## DEVELOPMENT APPLICATION ASSESSMENT REPORT

<b>Application Number:</b>	DA2021/2624
----------------------------	-------------

<b>Responsible Officer:</b>	Kye Miles
<b>Land to be developed (Address):</b>	Lot 55 DP 24563, 122 Riverview Road AVALON BEACH NSW 2107
<b>Proposed Development:</b>	Construction of a dwelling house
<b>Zoning:</b>	C4 Environmental Living
<b>Development Permissible:</b>	Yes
<b>Existing Use Rights:</b>	No
<b>Consent Authority:</b>	Northern Beaches Council
<b>Land and Environment Court Action:</b>	No
<b>Owner:</b>	William Lachlan Ian Macdonald Franca Macdonald
<b>Applicant:</b>	Interlock Construction Australia Pty Ltd

**Figure 1 - Proposed building envelope non-compliance on northern elevation.**

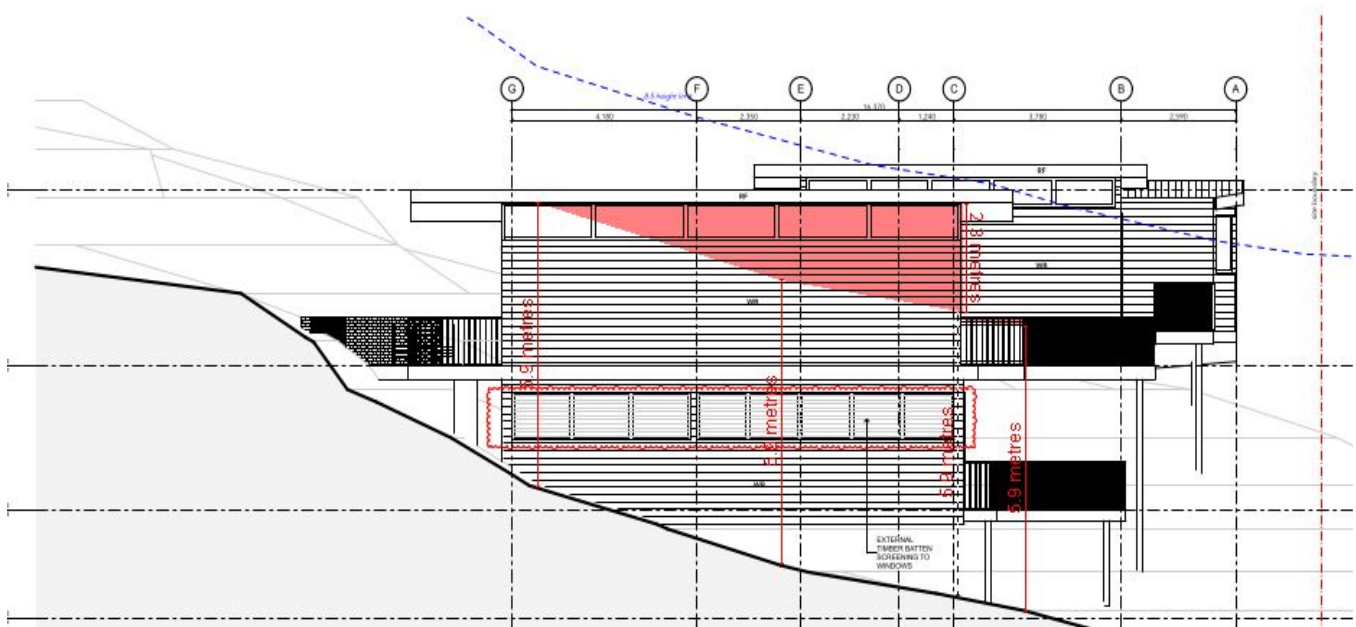
The proposed development encroaches into the prescribed building envelope along the northern elevation. This variation is represented in red within figure 1 below.

The proposal incorporates various design elements and varied setbacks to provide visual breaks along the northern elevation. Overall, the proportions of the encroaching elements are not considered to be unreasonably scaled or bulky.
